KSNA: JOHN WAYNE AIRPORT-ORANGE COUNTY, SANTA ANA, CA

DSNEE FIVE (RNAV) STAR

PRB RESULTS: RECOMMEND DISAPPROVAL

DSNEE.DSNEE5) FIG
AL-236 (FAA)
LONG BEACH, CALIFORNIA

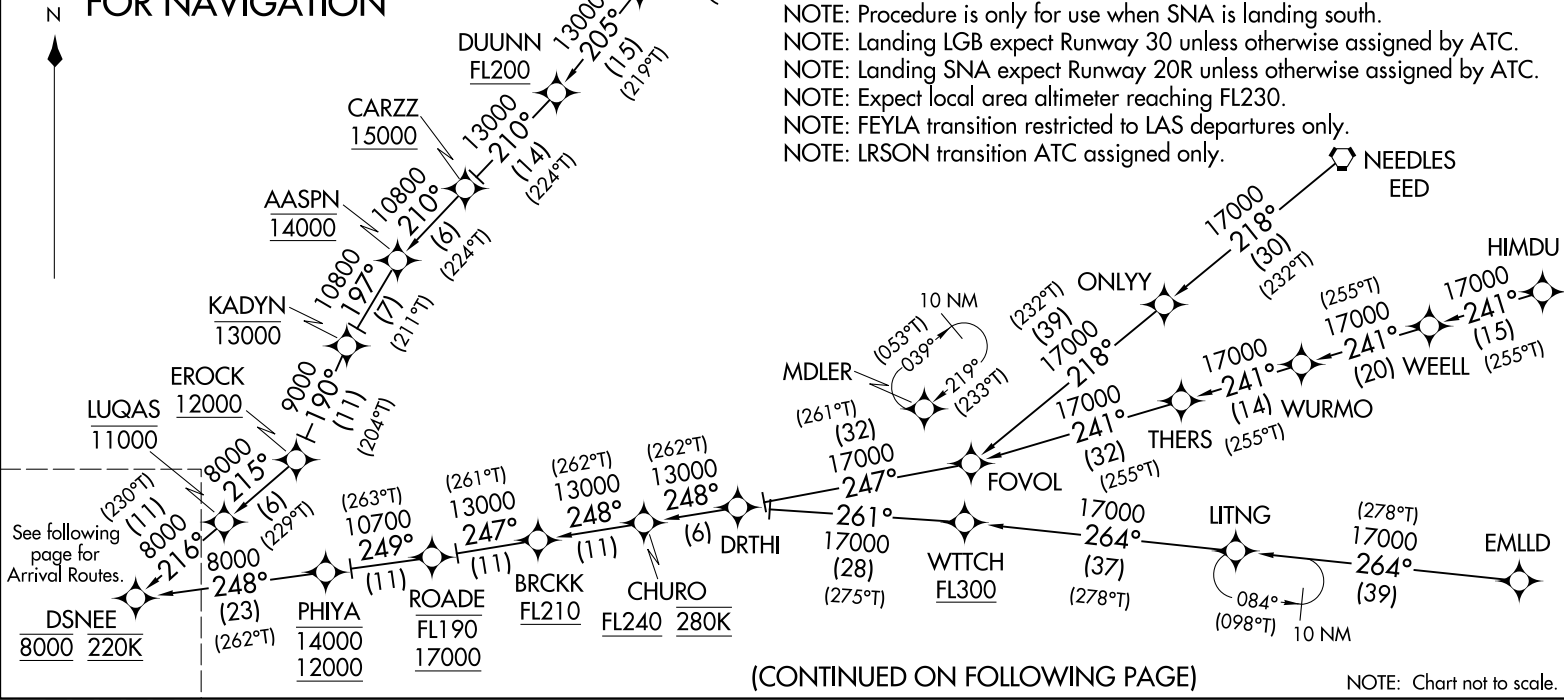
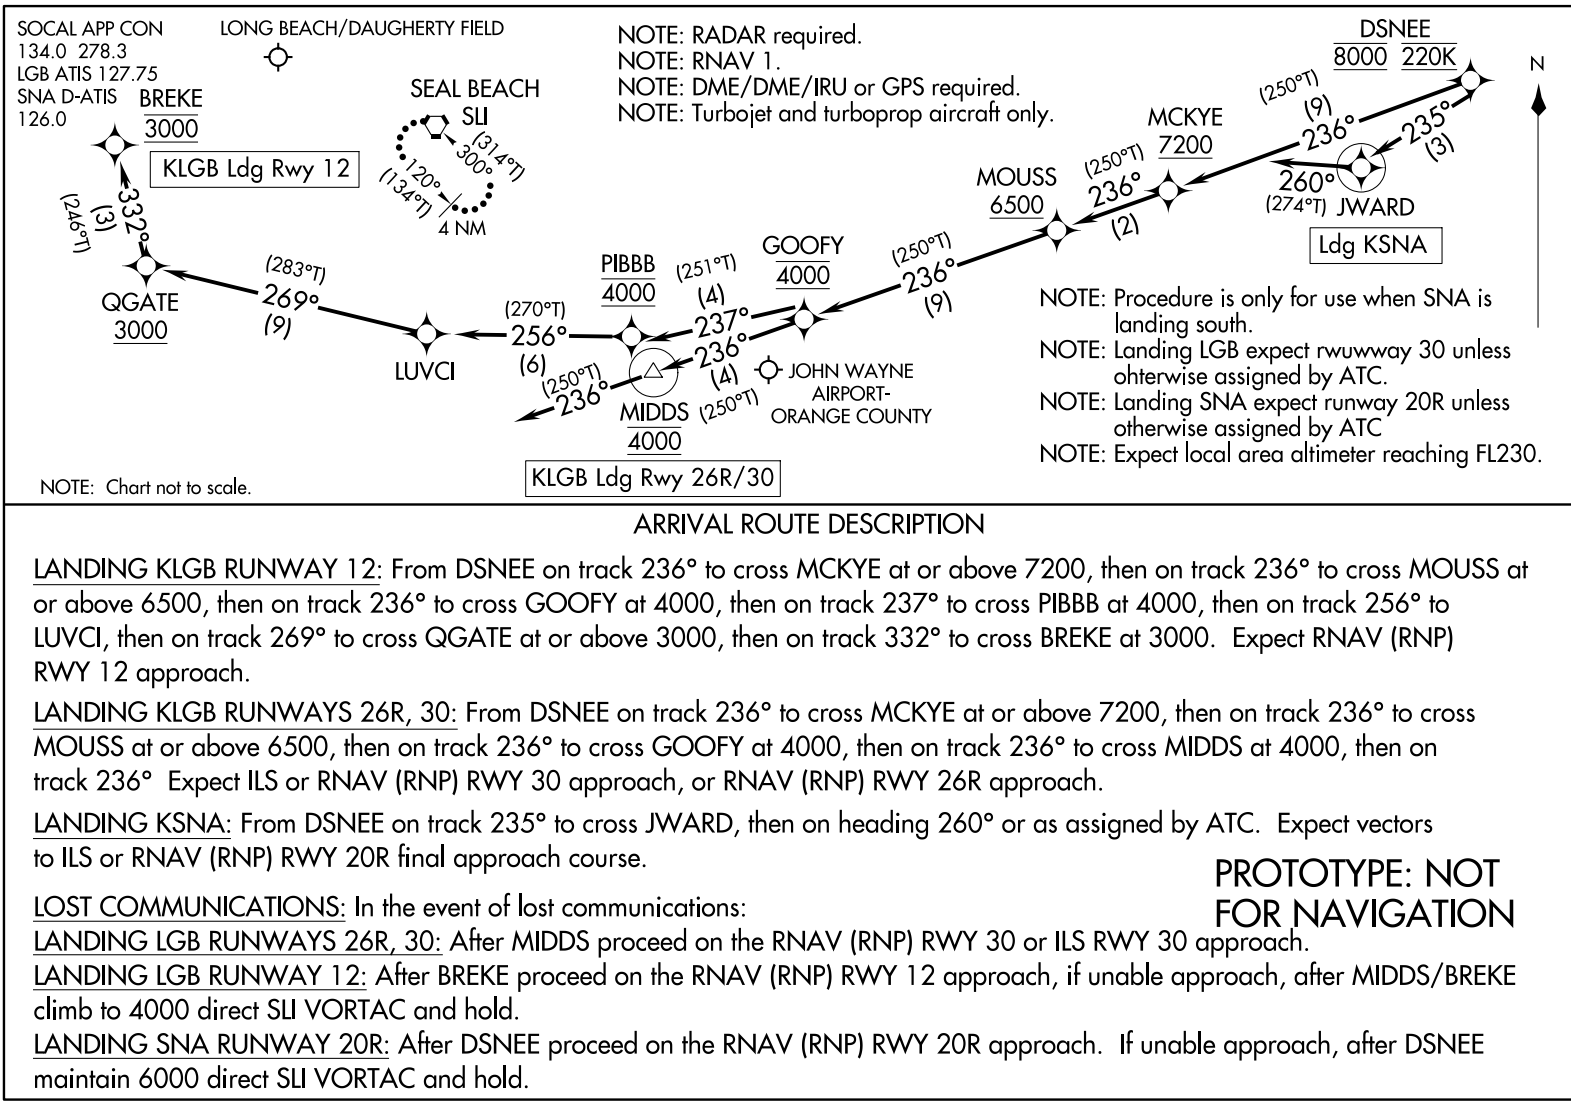
- IAW 8260.3D, 2-2-3 COMMON ROUTES ARE NOT DOCUMENTED CORRECTLY. THERE SHOULD BE A COMMON ROUTE FOR THE AIRCRAFT GOING TO LGB, FOLLOWED BY THE RUNWAY TRANSITIONS. THIS COULD BE EASILY FIXED WHILE STAYING WITHIN THE PARAMETERS OF CRITERIA.---AJV RESPONSE: Procedure documented same as DSNEE FOUR (currently published) and did not run into coding/fig issues; also 2-2-3 *does not indicate a star MUST* utilize a common route (only a common fix) for the primary arpt in which rwy transitions are established.
Criteria: 2-2-3. Routes and Transitions. A STAR serving a single airport consists of a common route, with optional e route and/or runway transitions. A STAR without a common route (such as a STAR with only a common point) may also be established if it contains at least two e route transitions or at least two runway transitions. STARs serving multiple airports *may* consist of separate common routes to each airport; however, all common routes must begin at a fix that serves all airports.

- IAW 8260.3D, 2-2-7 D (2): MOCA'S ARE NOT DOCUMENTED FOR EACH LEG OF THE TRANSITIONS. AJV RESPONSE: Please see 4-5-12(B)(8): MOCA. Enter the MOCA along the route segment. To reduce chart clutter, do not publish MOCAs less than 500 feet below the MEAs.
